**DOCUMENT 00 90 00  
ADDENDUM**

**ADDENDUM NO. [3]                      Date: November 20, 2018**

**RE:                      GLENWOOD COMMUNITY SCHOOL DISTRICT  
ATHLETIC COMPLEX IMPROVEMENTS BID PACKAGE 2 REBID  
400 SIVERS ROAD  
GLENWOOD, IOWA 51534  
HSR PROJECT NO. 18005**

GLENWOOD COMMUNITY SCHOOL DISTRICT  
ATHLETIC COMPLEX IMPROVEMENTS - BID PKG. #2 -  
REBID  
Project Location: 400 SIVERS RD.  
GLENWOOD, IA 51534  
Project Title:  
Sheet Title:  
FIRST FLOOR STADIUM PLAN

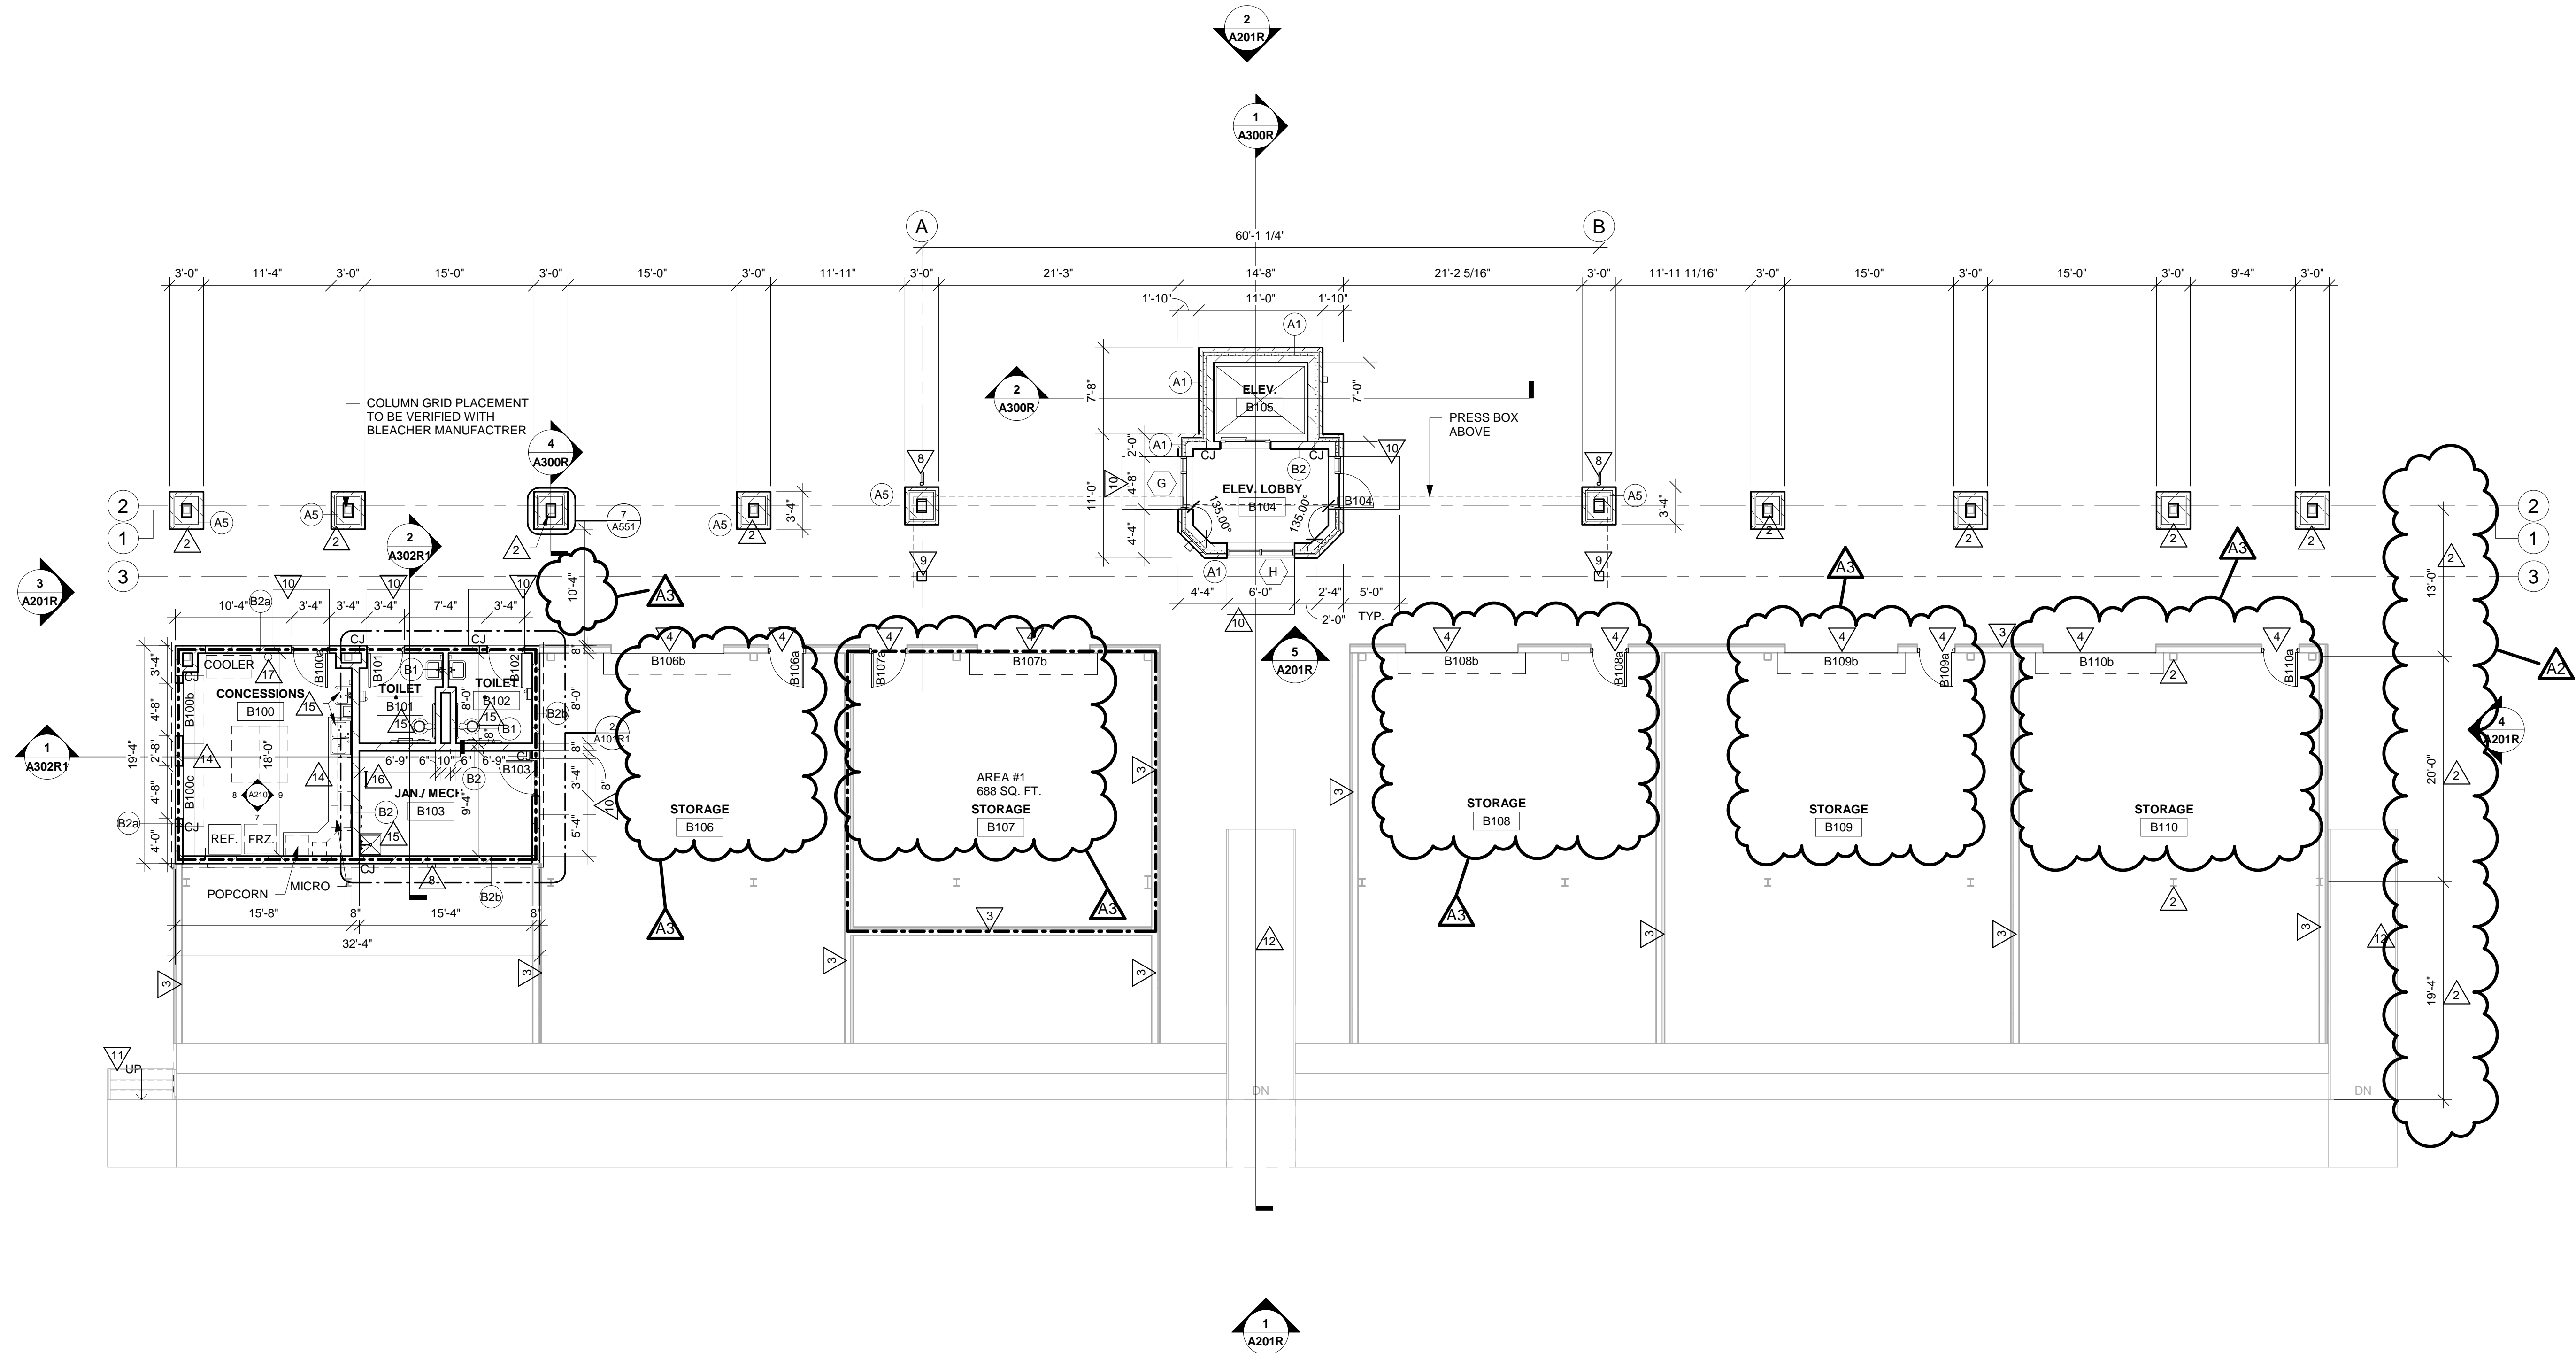
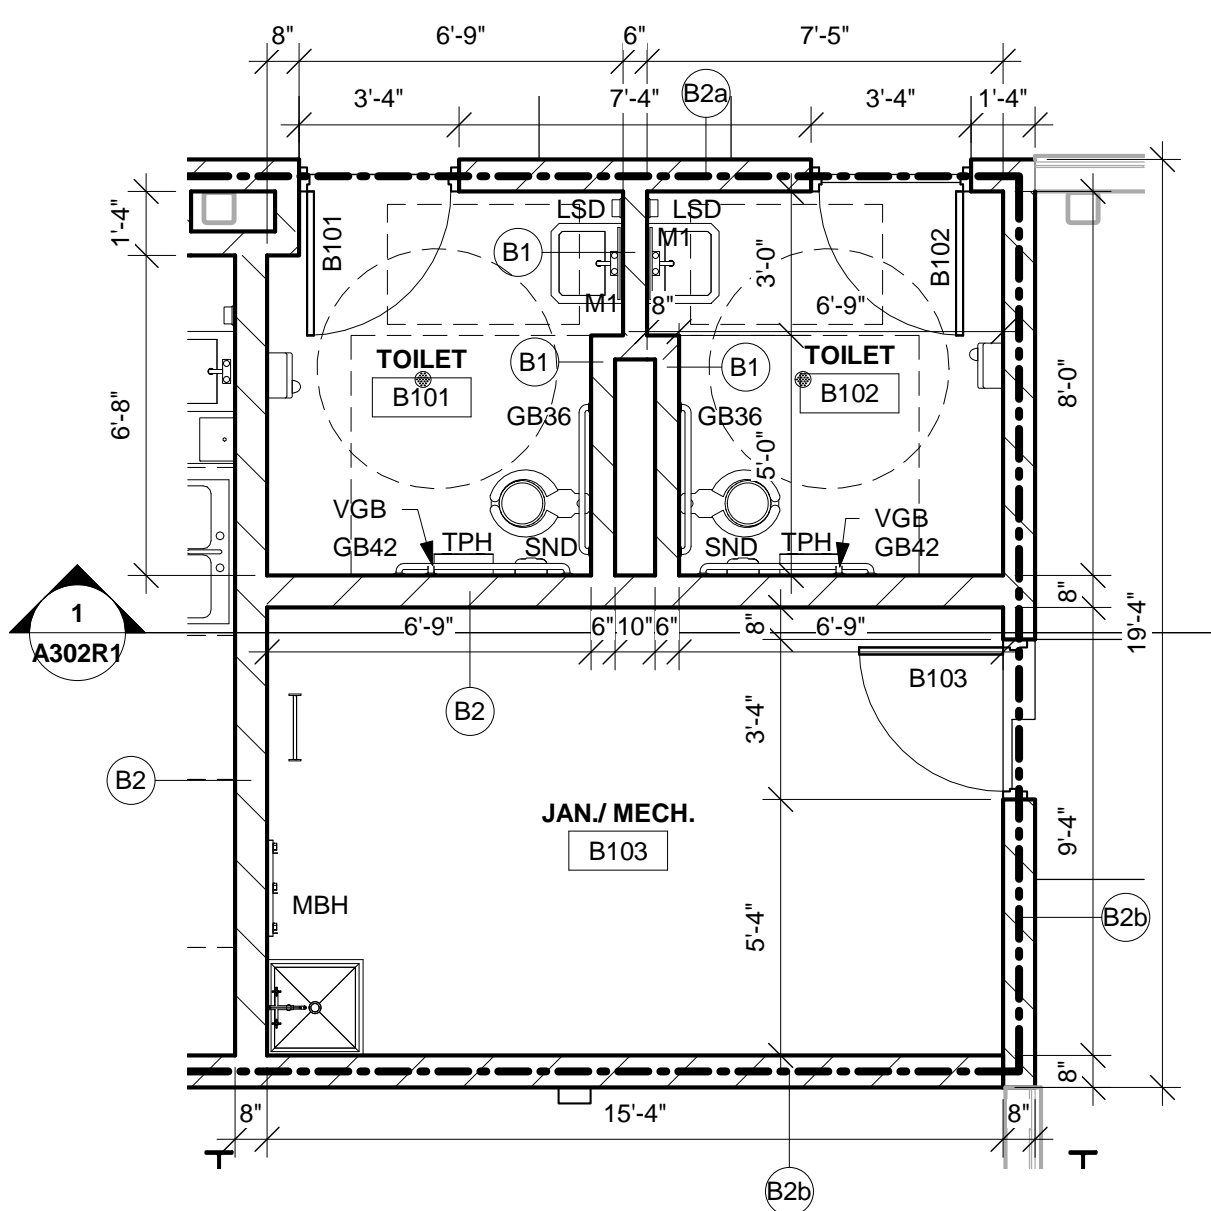
1. Sheet A101R1 FIRST FLOOR STADIUM PLAN 30 x 42 Drawing attached hereto. (Replaces A101R from Addendum 2.)
  - a. Revisions clouded on Drawing.
  - b. Key Note 4: Change "overhead" to "roll-up".

**1** PRESS BOX SECTION  
1/4" = 1'-0"

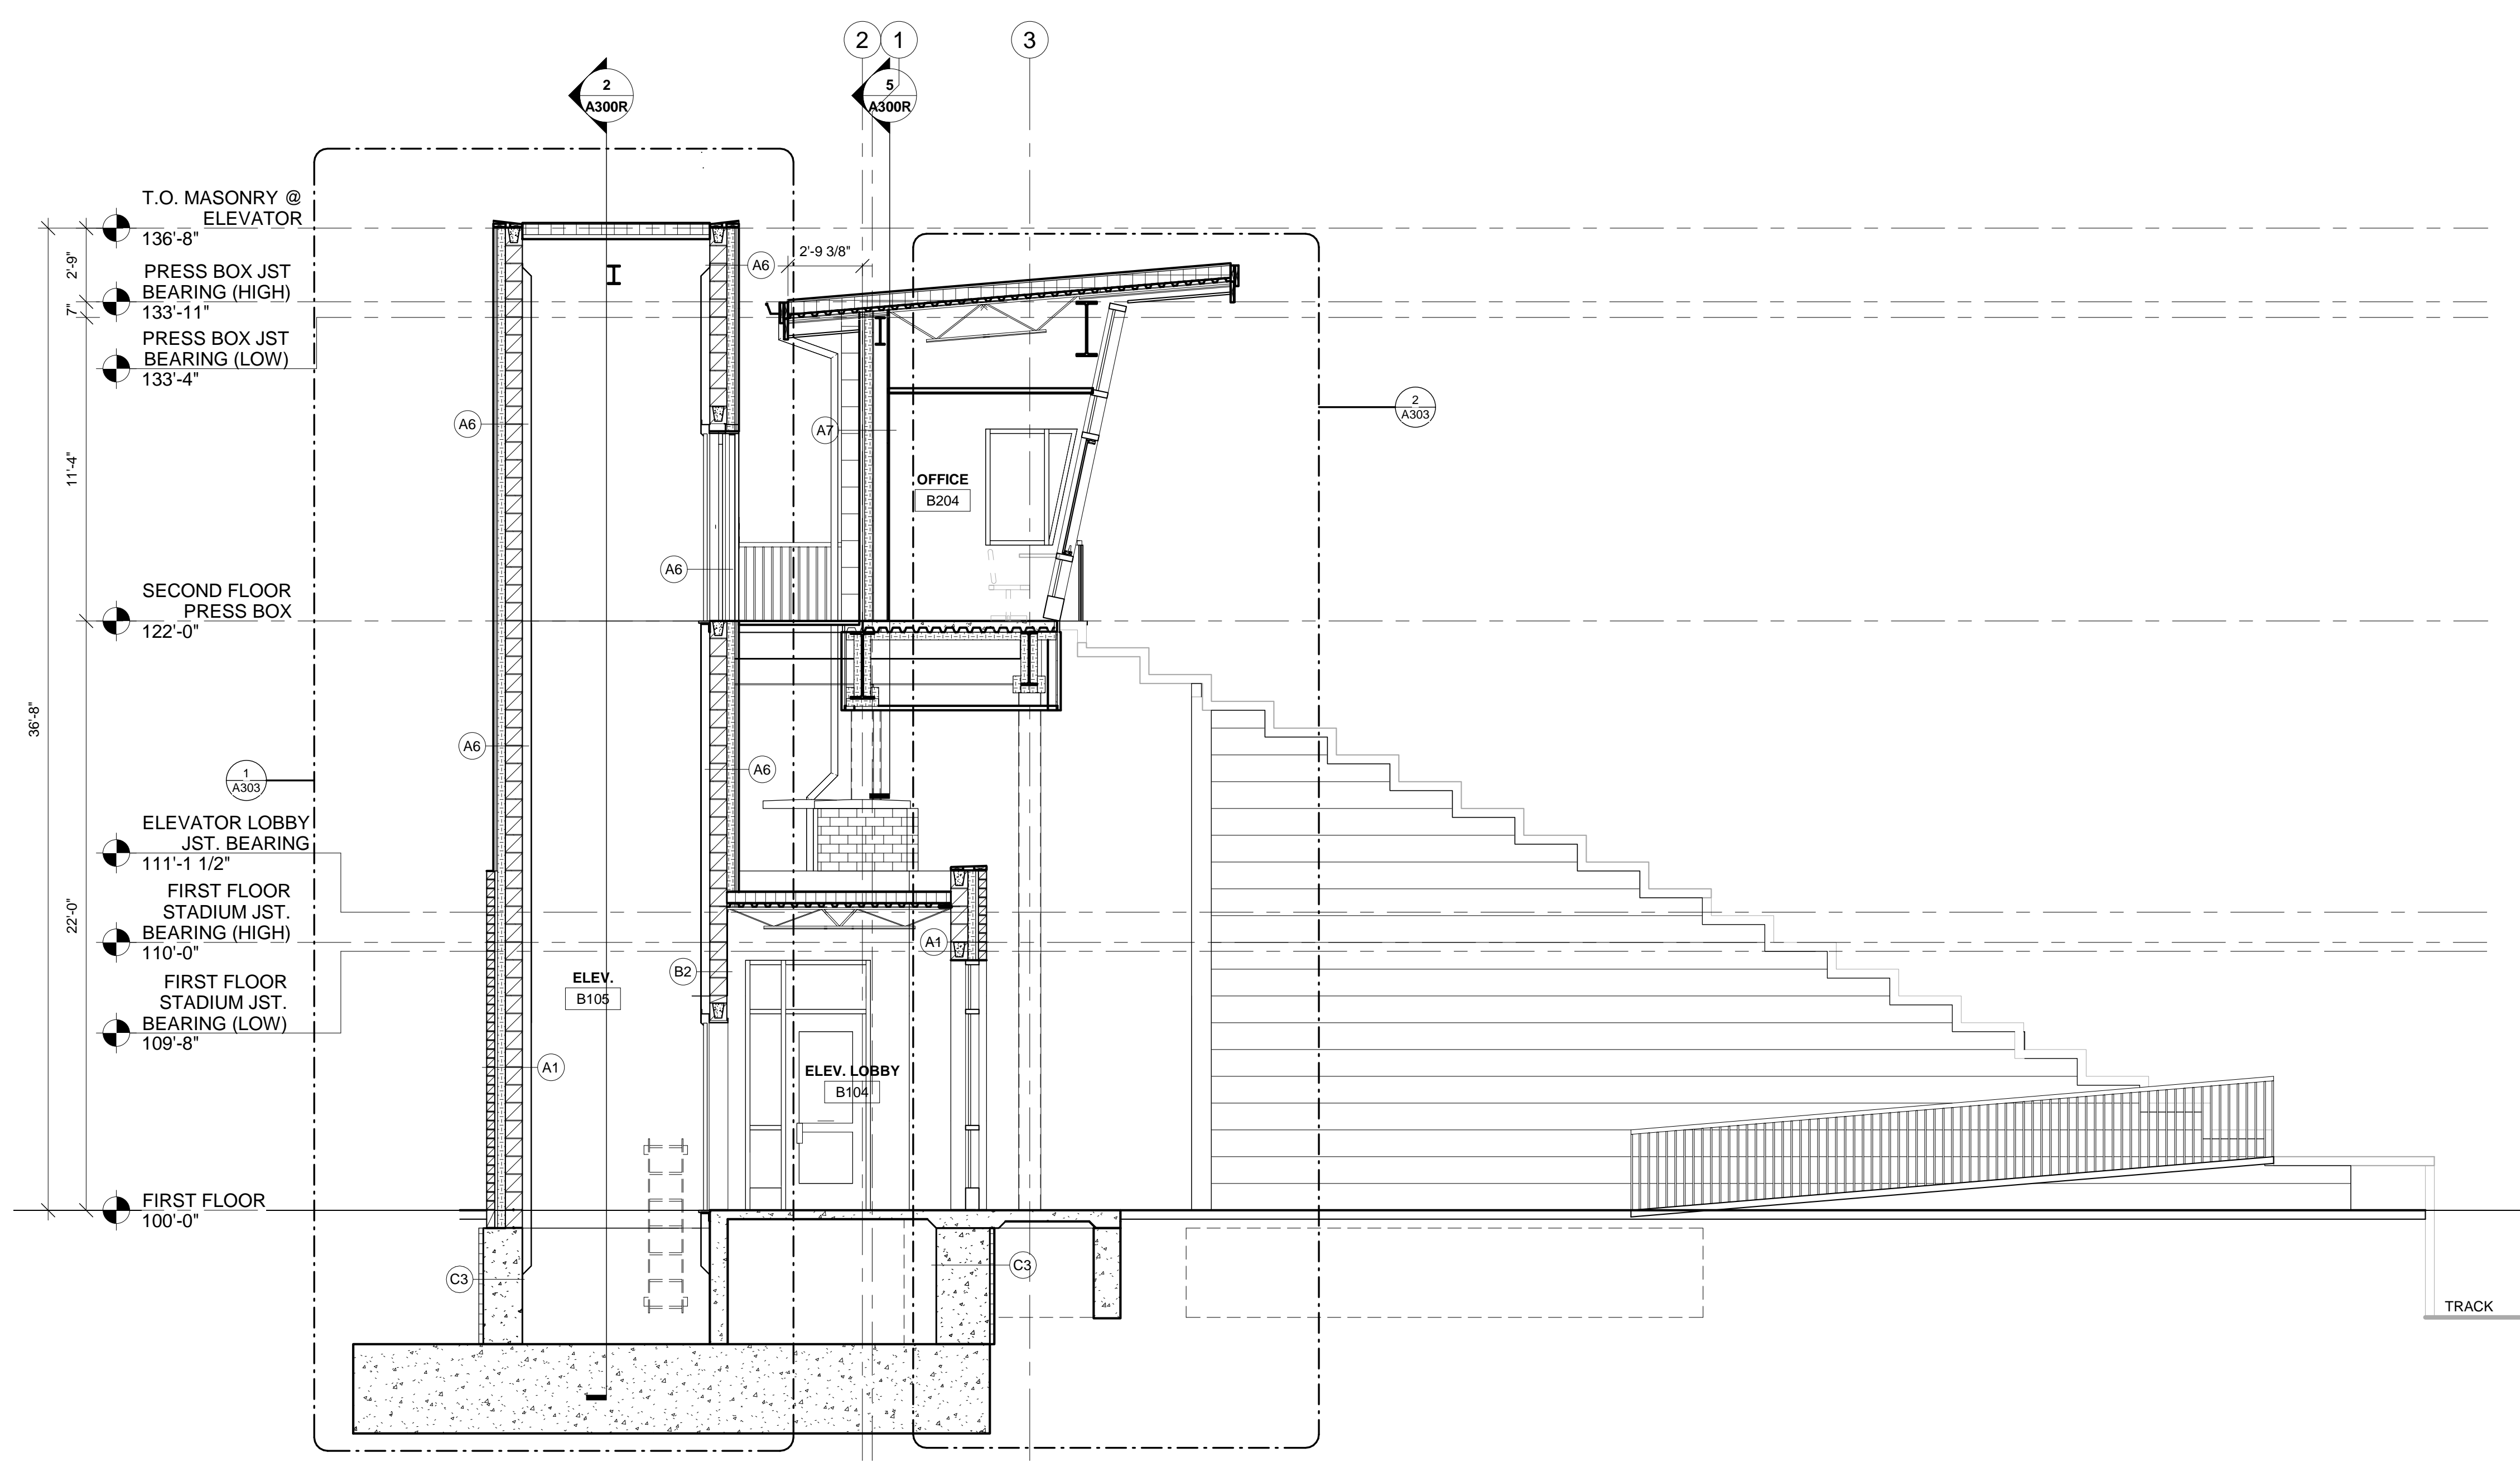
- a. Revisions clouded on Drawing.
14. Sheet A300R PRESSBOX BUILDING SECTIONS 30 x 42 Drawing attached hereto.
  - a. Revisions clouded on Drawing.
  - b. 1A300: Overhang should be the same as 9S301: 2'-9 3/8" & 3'-5 3/8" overhang from grid line 2.
